## **USB ENGINEERING CHANGE NOTICE**

Title: USB 2.0 Connect Timing Update

Applies to: Universal Serial Bus Specification, Revision 2.0

Figure 7-29 Connect Event Timing

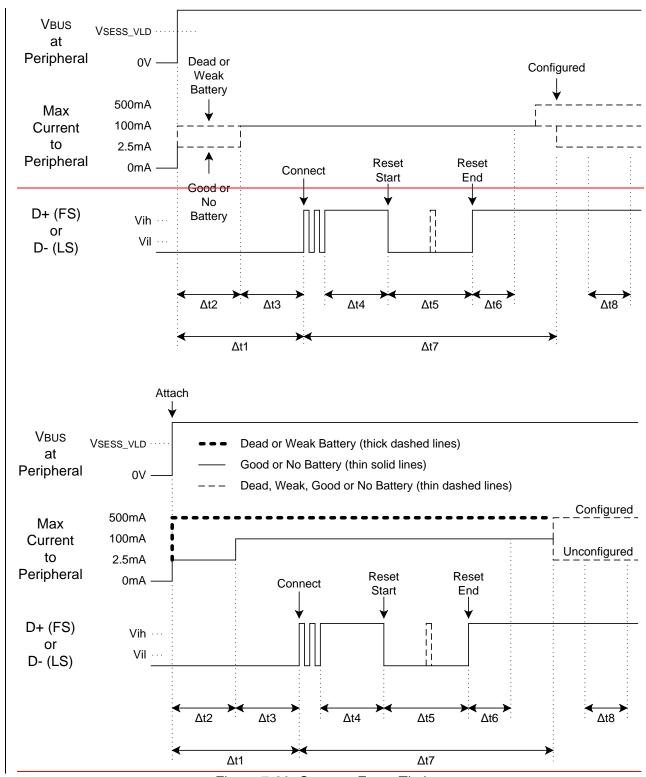
The USB 2.0 spec is not explicit in this issue. Figure 7-29 can be interpreted to imply a VBUS valid to connect time of 100ms. But Figure 7-29 does not distinguish between the VBUS valid event and the time at which the device draws current.

The USB spec would be modified such that the VBUS valid to connect time is explicitly called out. As well, the USB spec would differentiate between the VBUS valid event and the time at which the device starts to draw current from VBUS.

INSTRUCTIONS: In Section 7.1.7.3, replace Figure 7-29 as well as the previous one paragraph and following six paragraphs with the following.

Figure 7-29 shows the timing associated with a peripheral connecting to a host or hub port.

Δt1 (TSVLD\_CON\_PWD, TSVLD\_CON\_WKB) This is the maximum time from when VBUS crosses VSESS\_VLD to when the peripheral is required to connect (pull D+ or D- high) and be ready for enumeration. For bus powered peripherals and peripherals that are already powered up, this time

is TSVLD\_CON\_PWD. For portable devices with dead or weak batteries, this time is TSVLD\_CON\_WKB. During TSVLD\_CON\_WKB, a portable device with a dead or weak battery that is drawing up to IUNIT is required to signal the upstream port by driving D+ to VDP\_SRC. If a portable device with a dead or weak battery cannot connect and be enumerated after drawing IUNIT for TSVLD\_CON\_WKB, then it shall reduce its current draw to ISUSP is allowed to draw up to five times IUNIT.

- Δt2 (TSVLD\_UNIT) This time starts when VBUS crosses the VSESS\_VLD threshold, and ends 100ms\_TUNIT\_CON\_before the connect event. During this time, portable devices with dead or weak batteries are allowed to draw up to IUNIT from VBUS. All other peripherals are only allowed to draw up to ISUSP during this timegood batteries are allowed to draw up to ISUSP.

- Δt3 (TUNIT\_CON) This is the maximum time that a bus powered peripheral or a portable device with a good battery can draw up to IUNIT from VBUS before connecting.

- Δt4 (TCON\_RST) This is a debounce interval with a minimum duration of 100 ms that is provided by USB System Software. It ensures that the electrical and mechanical connection is stable before software attempts to reset the attached device. The interval starts when the USB System Software is notified of a connect event (D+ or D- pulled high). The interval restarts if there is a disconnect event. The debounce interval ensures that power is stable at the device for at least 100 ms before resetting the peripheral.

- Δt5 (TDRST) This is the period of time hubs drive reset to a peripheral. Refer to Section 7.1.7.5 and Section 11.5.1.5 for details.
- Δt6 (TRSTRCY) The USB System Software guarantees a minimum of 10 ms for reset recovery. Peripheral response to any bus transactions addressed to the default device address during the reset recovery time is undefined.

- Δt7 (TCON\_ISUSP) After connecting, a peripheral with a good battery is allowed to draw up to ene unit load current[UNIT, and a peripheral with a dead or weak battery is allowed to draw up to five times IUNIT, for a time of TCON\_ISUSP. If a peripheral is not configured after TCON\_ISUSP, then it is required to reduce its current draw to ISSUSP., before having to obey the rules of dropping down to suspend current. If, during this time, a peripheral becomes configured, it is then allowed to draw its configured current.

- Δt8 (T2SUSP) After a time of TCON\_ISUSP from the connect event, a peripheral must obey the rules of going into suspend (see Section 7.1.7.6).
